**STAFF REPORT: OCTOBER 8, 2025 MEETING**

**APPLICATION NUMBER: HDC2025-00591**

**ADDRESS: 2233 PARK AVENUE (AKA IODENT BUILDING)**

**SCOPE: REPLACE WOOD WINDOWS WITH ALUMINUM-CLAD WOOD WINDOWS**

Above: Staff photo of one of the historic windows that shows the level of detail and dimensionality to the original framing and mullion.

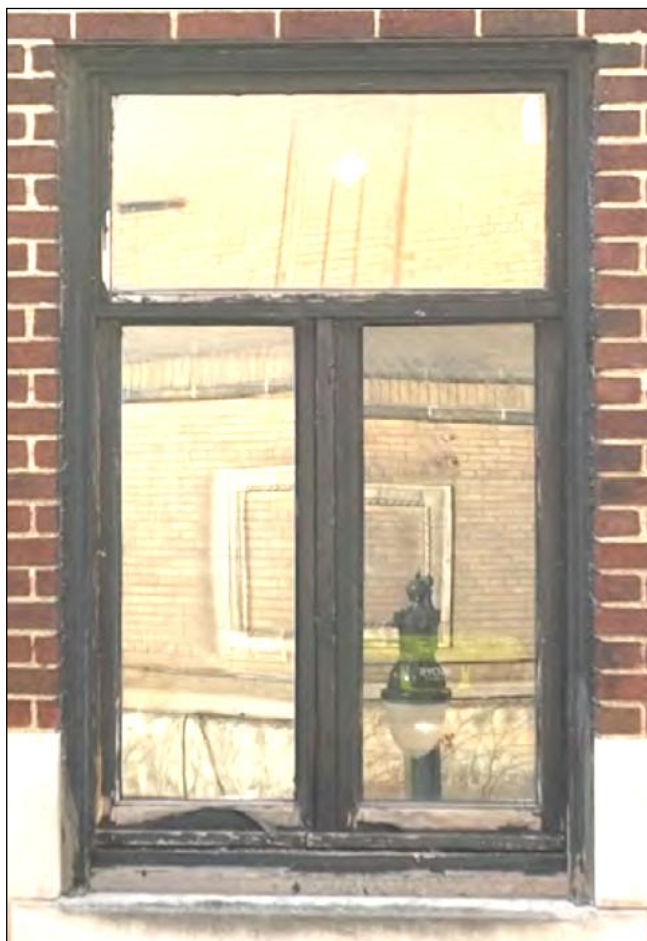
- The perspective of the building in the above photo offers a clear view of the proportional width of the vertical element created by the closed French windows against the width of the fixed transom’s lower frame, creating an equally dimensioned “T”.

- It is staff's opinion that the existing historic windows are a distinctive character-defining feature of the building. The "T" design creates a uniform division of the window opening, equaling emphasizing the horizontal and vertical patterns of the stone detailing on the three primary exterior walls.
- The applicant's photos of the historic windows (an interior and exterior photo of each historic window is included in the application documents, only one opening is shown here) show wood frames that don't appear to be deteriorated beyond repair; they are intact and retain a smooth paint finish. The level of deterioration to the exterior framing is greater but is proportional to its daily exposure to the elements. The 100+ year old windows appear to be repairable, with most weathering at the horizontal components.
